# NETAFIM USA PRODUCT UPDATE

APRIL 2010

## LOW PRESSURE SPINE UPGRADE KIT ALLOWS FILTER FLUSHING AT 30 psi FOR 2" & 3" DISC-KLEEN AND GALAXY DISC-KLEEN FILTERS

### LOW PRESSURE SPINE UPGRADE KIT COMPONENTS

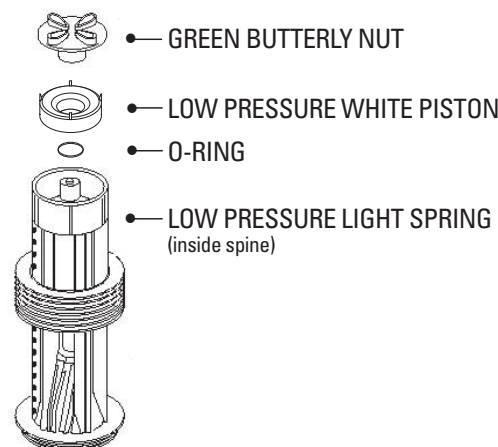
Netafim is now offering a Low Pressure Spine Upgrade Kit for existing Disc-Kleen filters. Retrofitting to the low pressure spine allows the filter to flush at 30 psi instead of 40 psi - saving energy costs. A lower flushing pressure maintains water flow to the field during the flushing cycle ensuring higher uniformity.

- From 2000-2005, filters used a stiff spring and it must be changed to the low pressure light spring.
- From 2005-2009, filters used a light spring and it does not need to be changed.
- Identifying a stiff spring from a light spring? When the old piston is removed from the spine and there is a triangular plate with 3 screws, then the spring below that piece is a light spring. If there is a round plate with 3 screws, then it's a stiff spring and needs to be replaced.

- All filter spines must be upgraded.
- An Accelerator Relay must be added to each backflush valve to maintain a short valve transition from filtration to flushing mode (Item #71680-000790, List Price \$144.00 each).
